Subject: Submittal of Replacement Pages to Update the NAC-UMS® FSAR from Revision 3 to Revision 4 (Docket No. 72-1015)

10 CFR 72.48 Evaluation Summary Report
for the
NAC-UMS® Universal Storage System
(Docket No. 72-1015)

72.48 Determination Checklist ID #NAC-04-UMS-009

DETAIL E-E

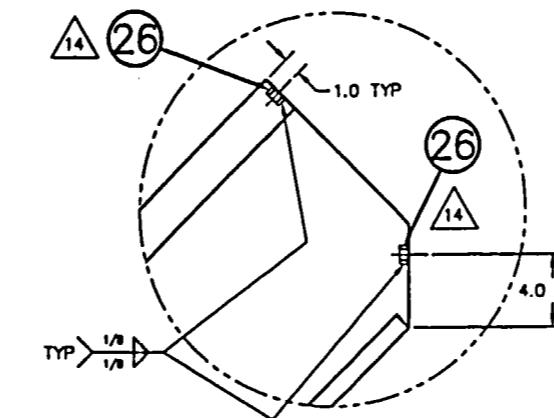
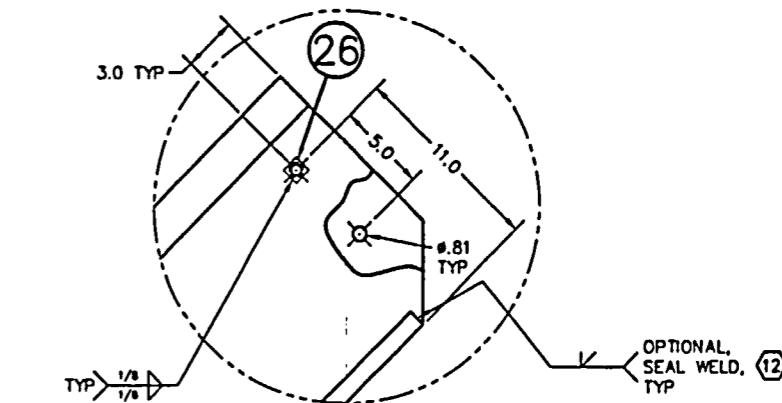
Revision 12 of Drawing 790-561 adds an optional bevel weld callout, far side, "Seal weld, TYP" to Optional Configuration Detail E-E, for the vertical seam between Items 12 and 13; and updates the drawing border and deletes all weight and scale callouts from the field on the drawing.

Figure 3.4.2-1 Universal Storage System Welded Canister Closure

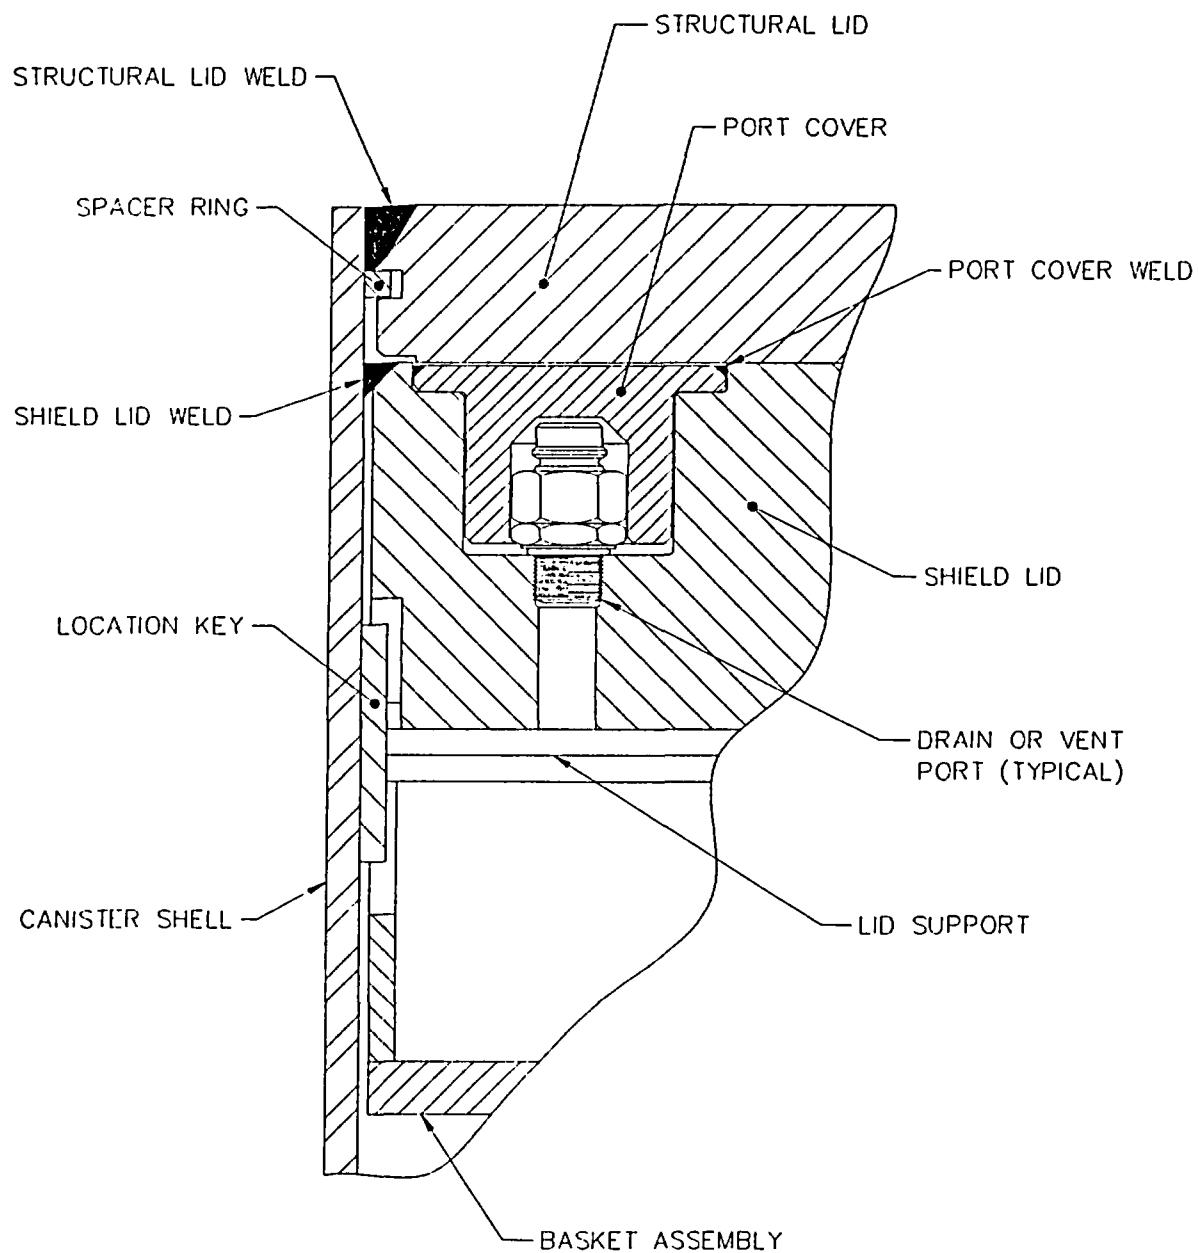
Chapter 3, Page 3.4.2-1 (Figure 3.4.2-1); Chapter 7, pages 7.1-3, 7.1-5, 7.1-8 (Figure 7.1-2) & 7.5-1; Chapter 12, pages 12C3-9, 12C3-12, 12C3-13, 12C3-16, 12C3-19, 12C3-20, 12C3-22 & 12C3-24.

Figure 4.4.1.3-2 Three-Dimensional Transfer Cask and Canister Model - BWR

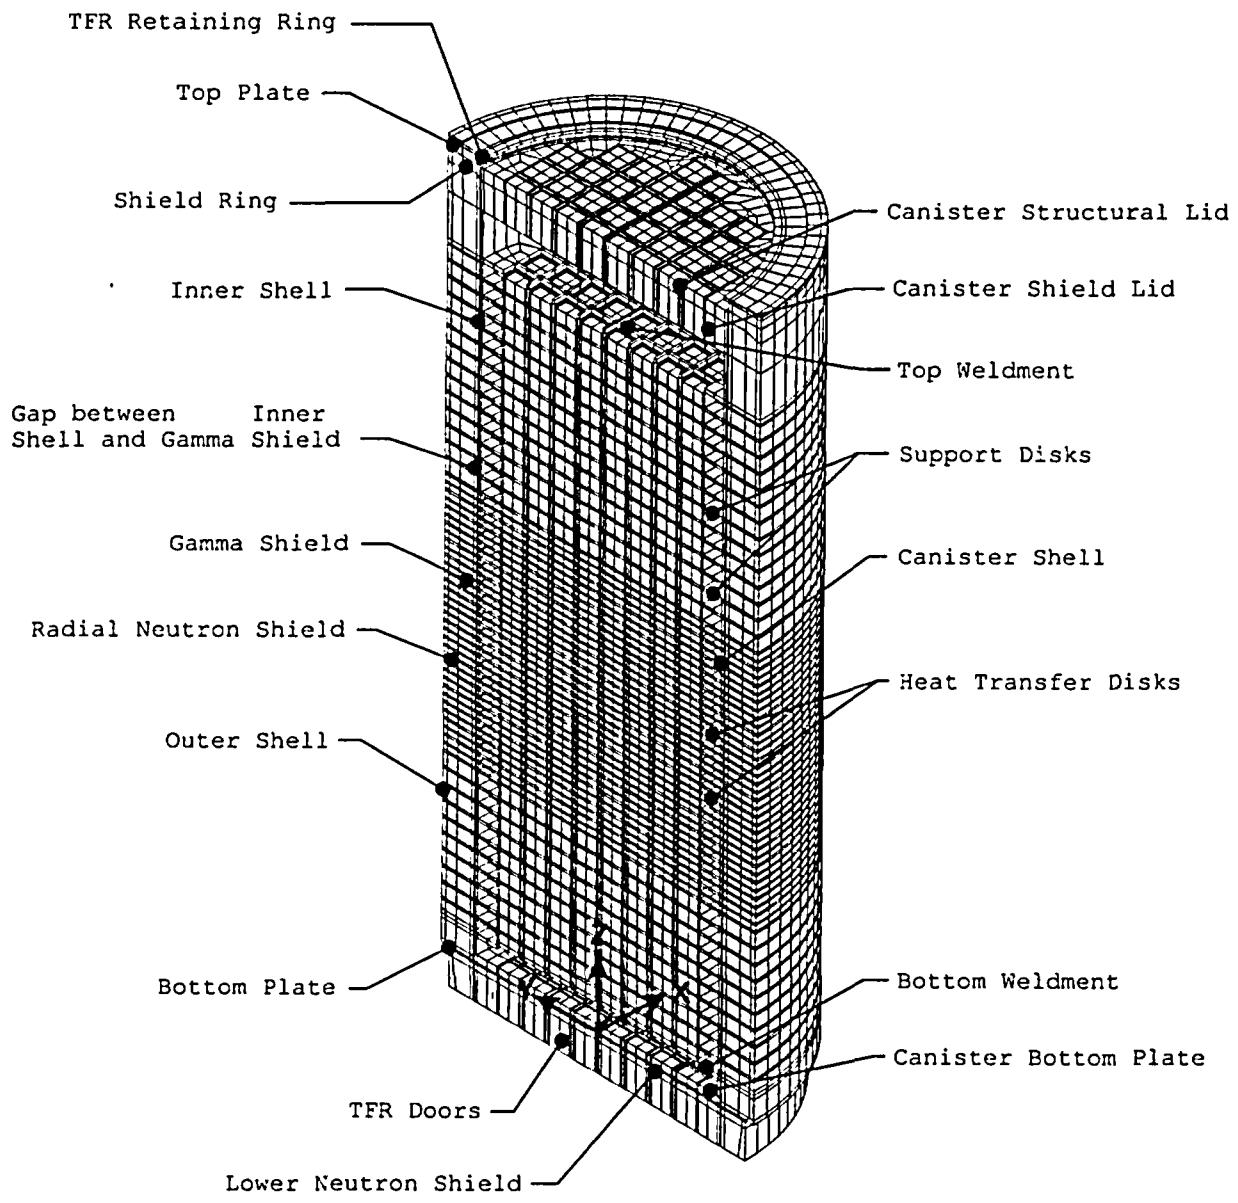
Page 4.4.1-27	72.48/DCR(L) 790-FSAR-3A	Section 4.4.1.3, 2 nd paragraph – added sentences 5 & 6
Page 4.4.1-28	72.48/DCR(L) 790-FSAR-3A	1 st full paragraph, 1 st & 2 nd sentences – revised throughout
Page 4.4.1-30, Figure 4.4.1.3-2	72.48/DCR(L) 790-FSAR-3I	Text box – deleted “(water/helium)”

Figure 4.4.1.6-1 Two-Dimensional Fuel Tube Model: PWR Fuel

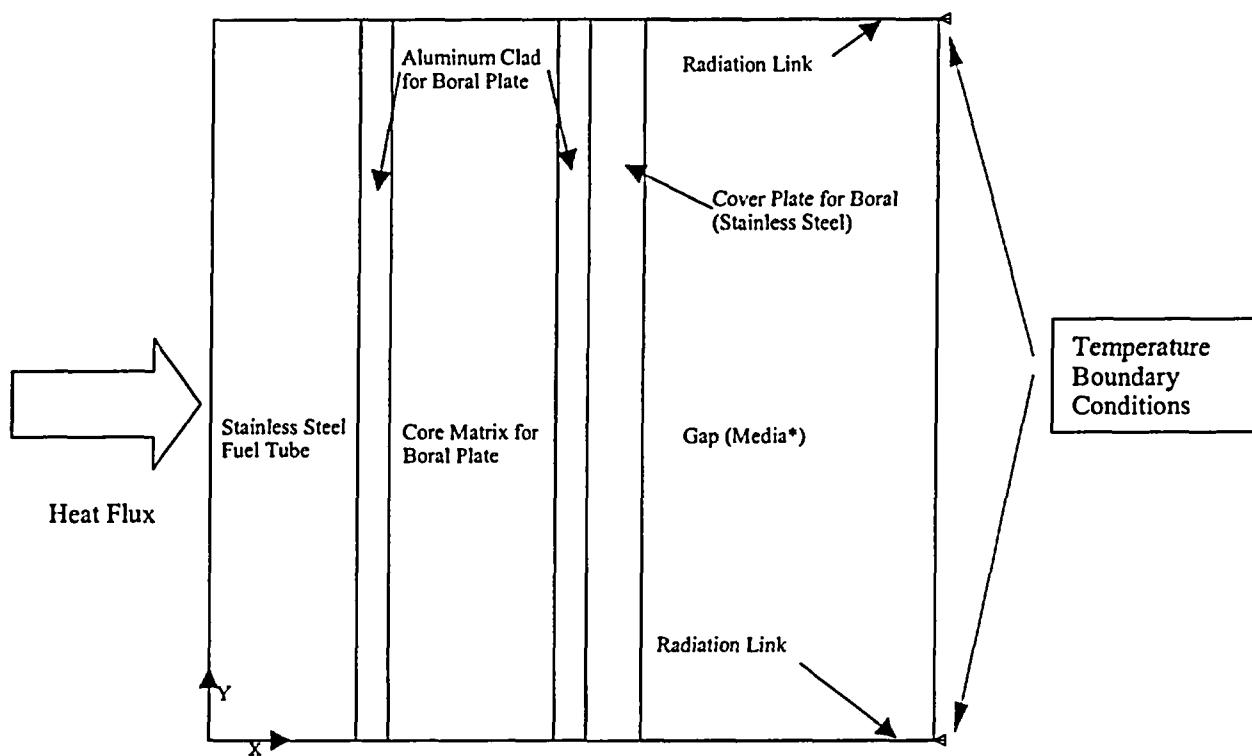
Revises Chapter 4, Sections 4.4.1 & 4.4.3, to add saturated steam to the media considered in the thermal analysis for transfer conditions.

Chapter 4, pages 4.4.1-2, 4.4.1-30 (Figure 4.4.1.3-2) 4.4.1-35, 4.4.1-38, 4.4.1-41 (Figure 4.4.1.6-1), 4.4.1-42 (Figure 4.4.1.6-2), 4.4.1-43 (Figure 4.4.1.6-3), & Section 4.4.3 (page 4.4.3-1).

*Media can be water, vacuum, helium or saturated steam.
